**SAN ANTONIO WATER SYSTEM
C-5 CULEBRA – CASTROVILLE TO LAREDO AND C-28 ZARZAMORA CREEK SAN
GABRIEL TO NW 23RD STREET, PHASE 1A
SAWS JOB NO. 14-4507
LAREDO STREET TO LOMA VISTA TO CHIHUAHUA PROJECT
SAWS JOB NO.14-4007**

ADDENDUM NO. 3

October 21, 2014

Consulting Engineer: CP&Y, Inc., TBEF Registration, #F-1741

SHEET C-A-08
SHEET 15 OF 45

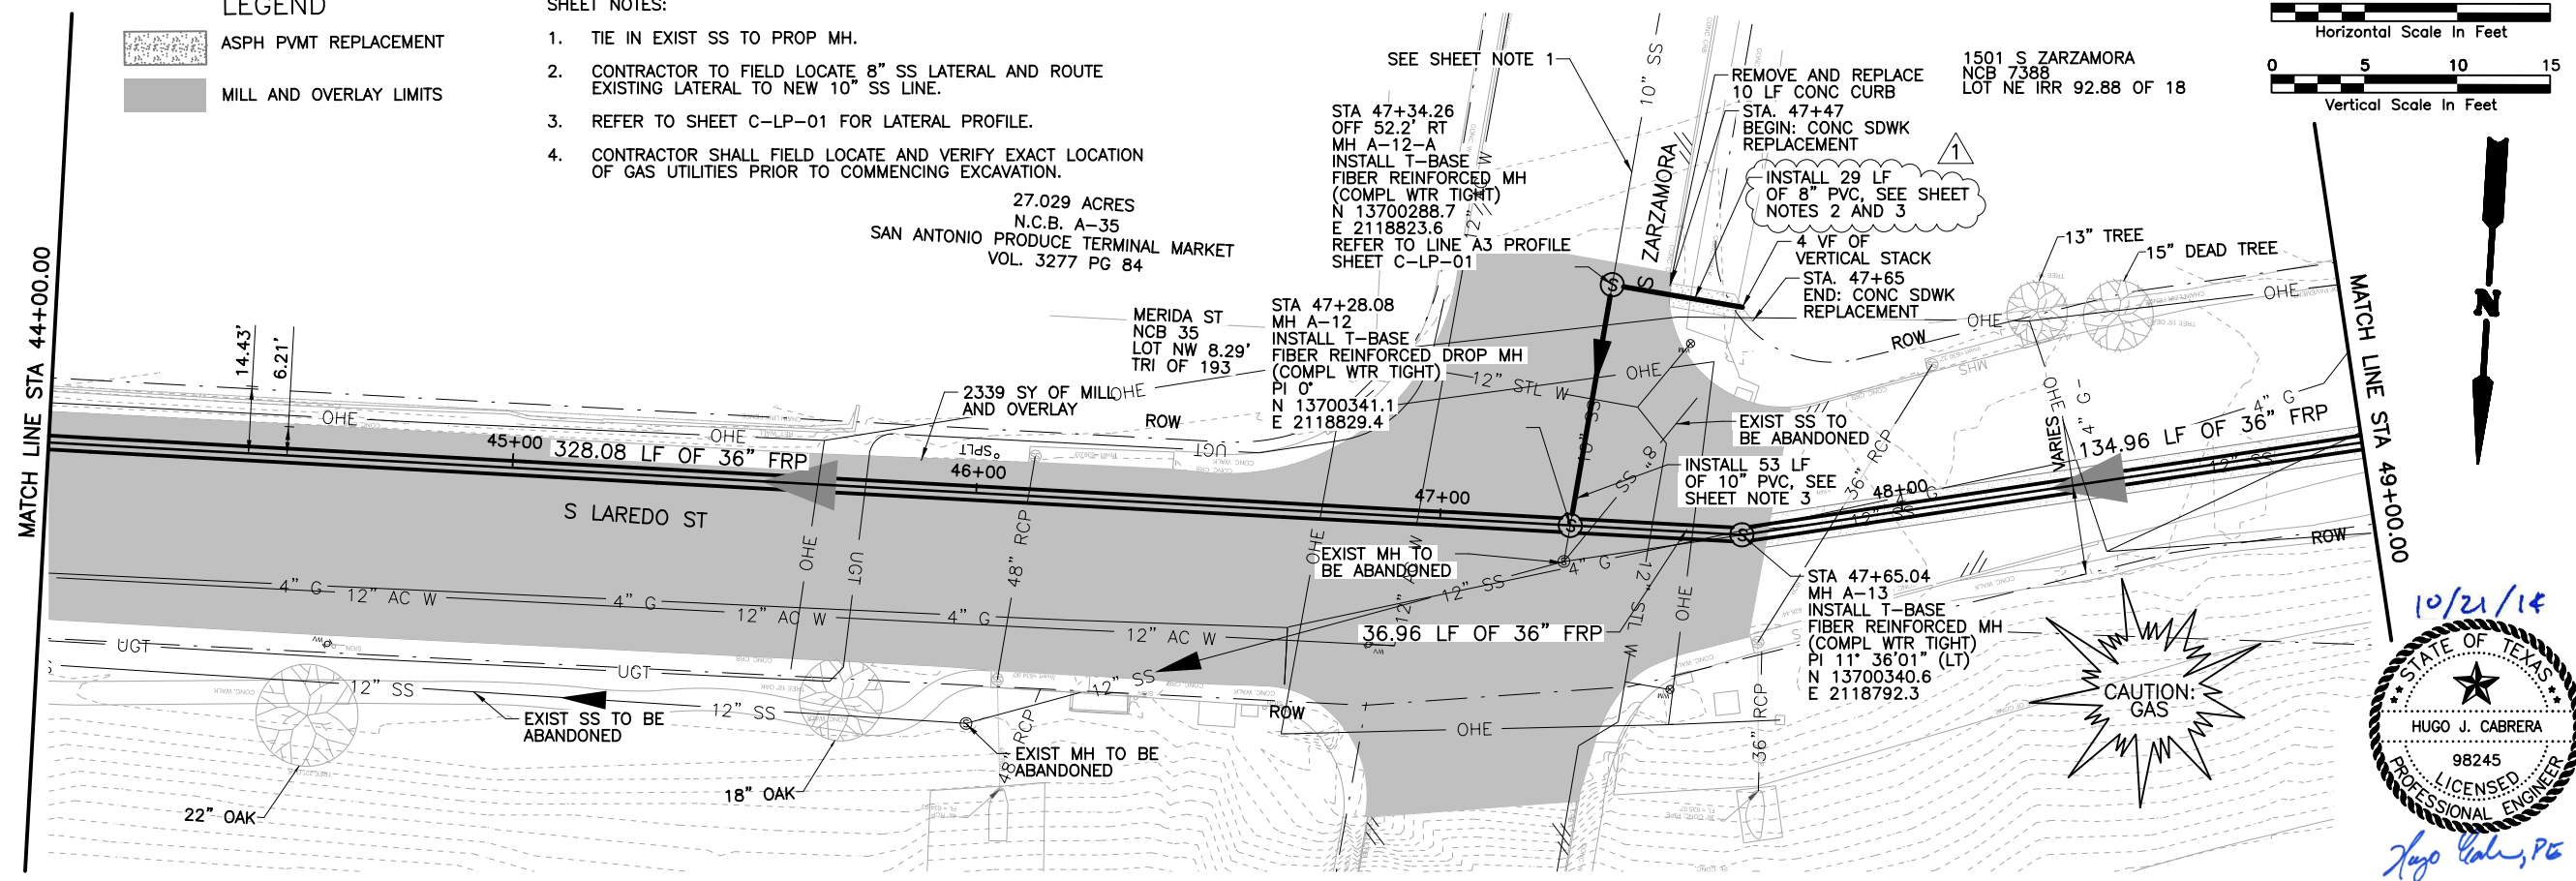
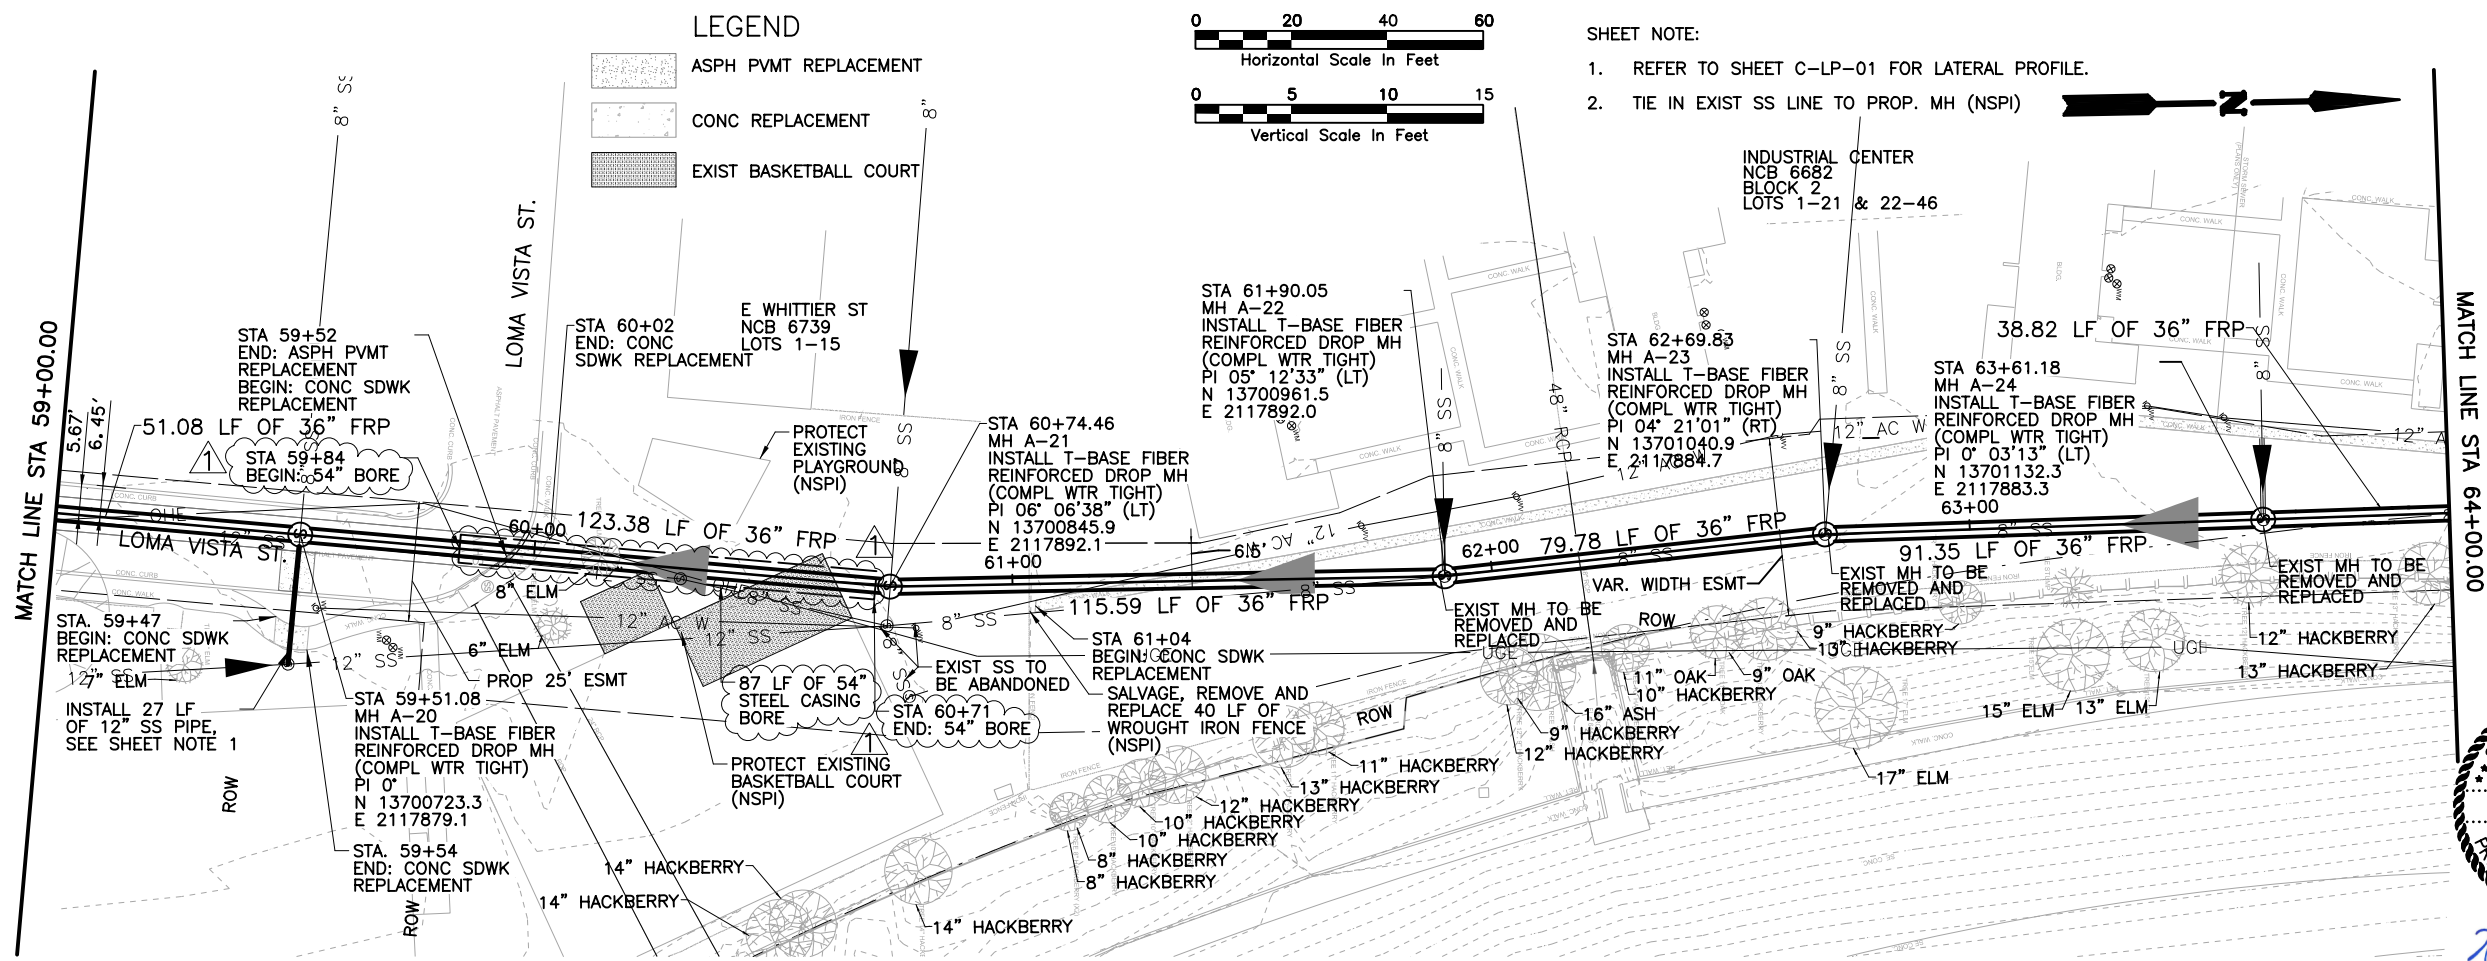
A. Delete Sheet C-A-08, Sheet 15 of 45, and replace with attached sheet C-A-08.

SAN ANTONIO WATER SYSTEM
 PHASE 1 C-5 - CULEBRA - CASTROVILLE TO LAREDO &
 C-28 - ZARZAMORA CREEK - SAN GABRIEL TO NW 23RD ST
 P&P - STA 59+00 TO STA 64+00

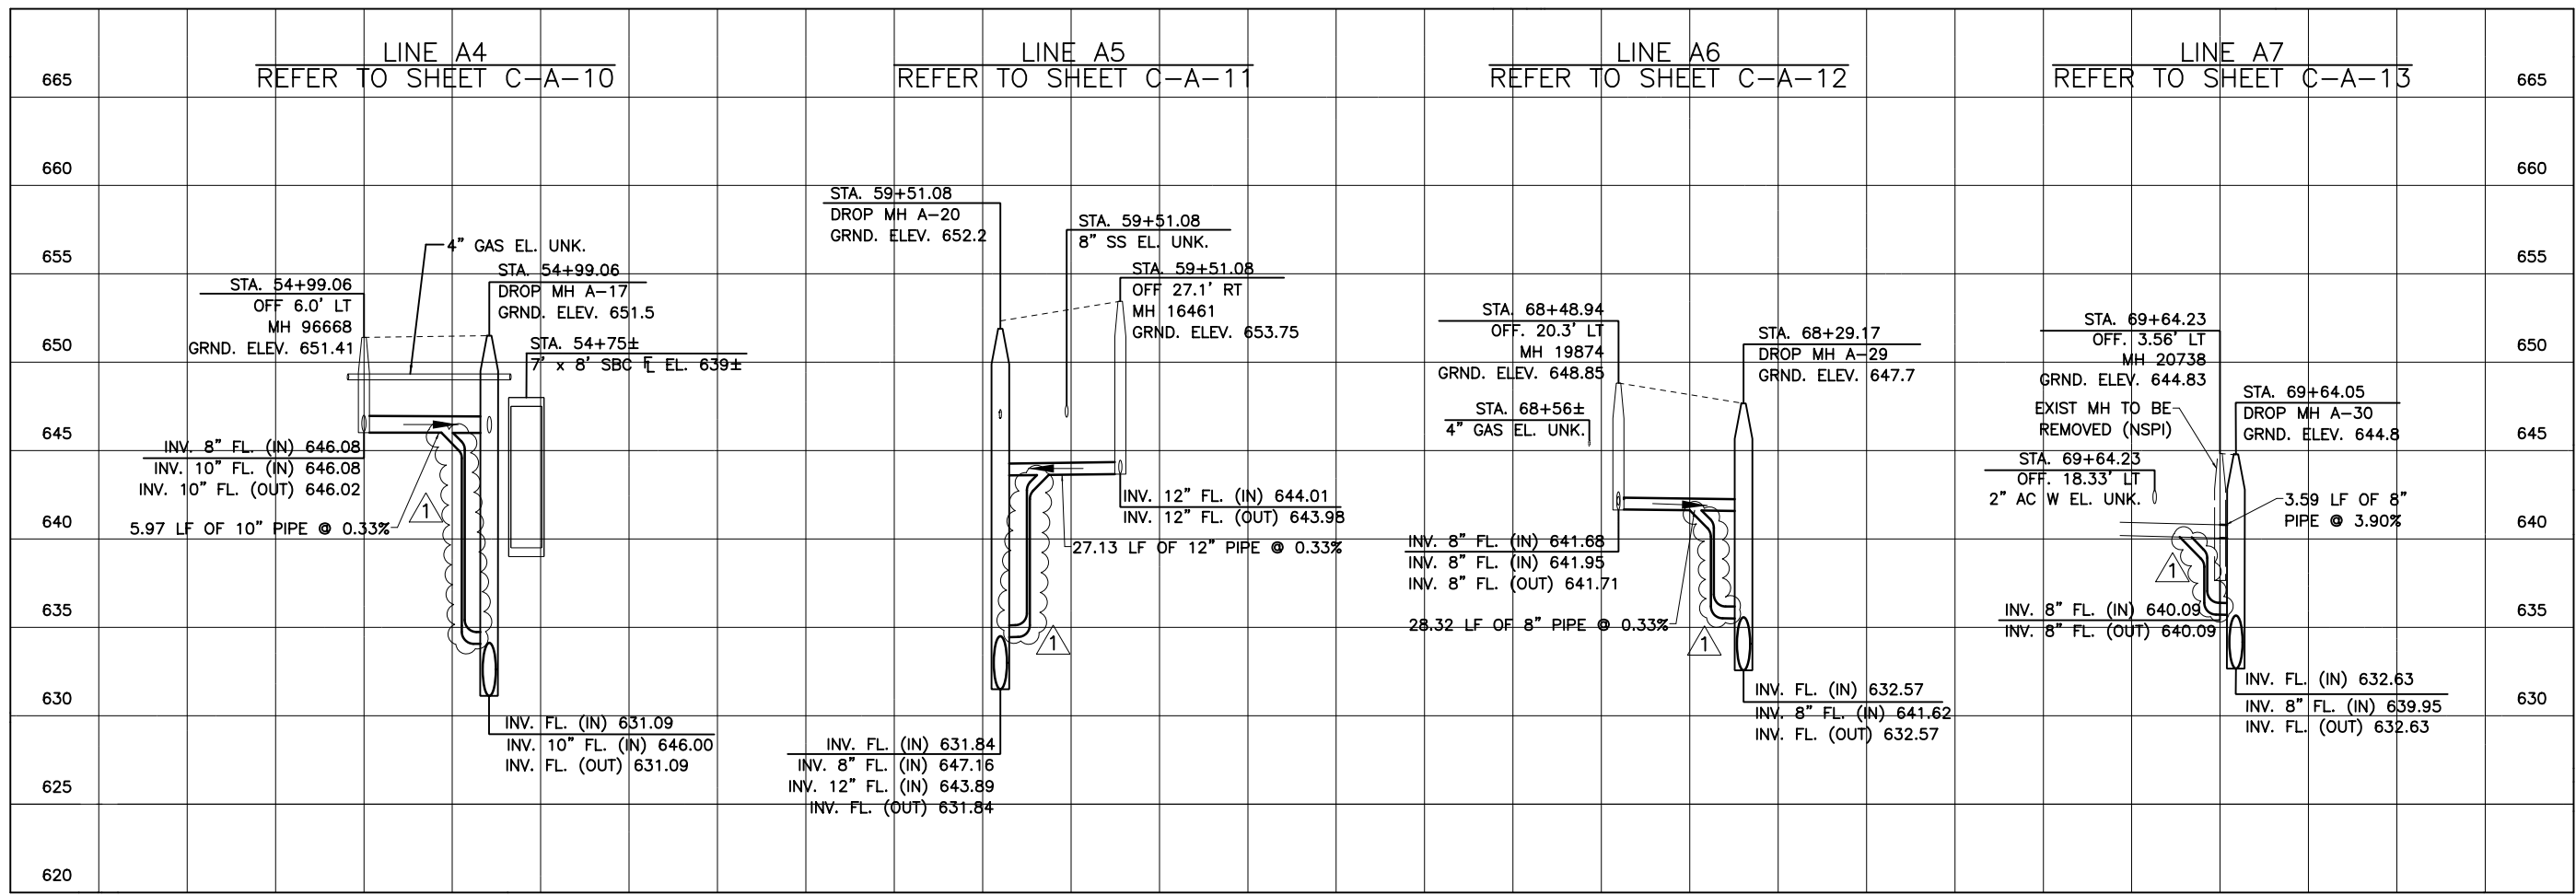
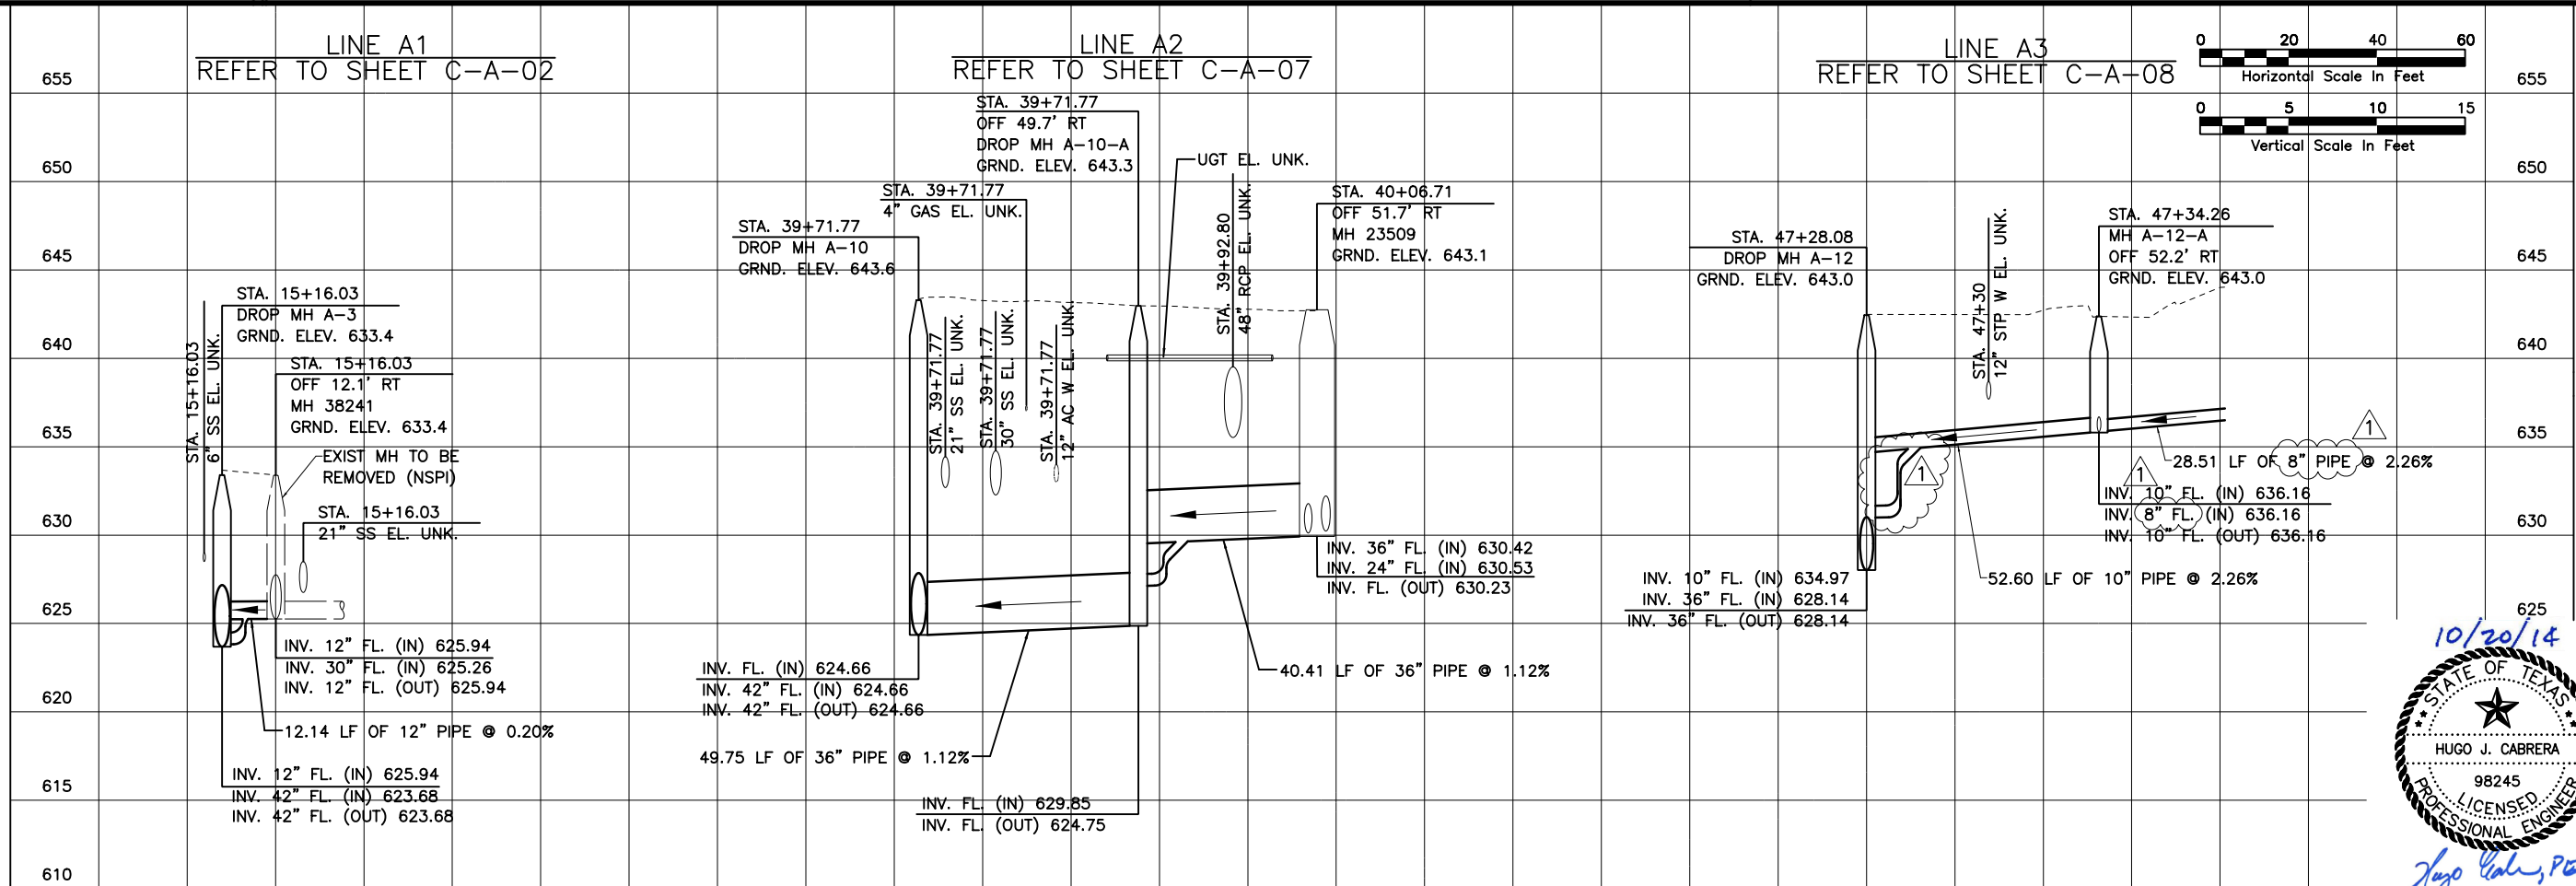
B. Delete Sheet C-A-11, Sheet 18 of 45, and replace with attached sheet C-A-11.

- **Plan sheet 18 of 45 shows an 8" Elm tree on-centerline of the proposed sewer at approx. STA 60+20, please verify that the contractor will be allowed to remove the 8" Elm.**

A: This plan will be revised to show the proposed bore being extended to the south to avoid the removal of said tree.
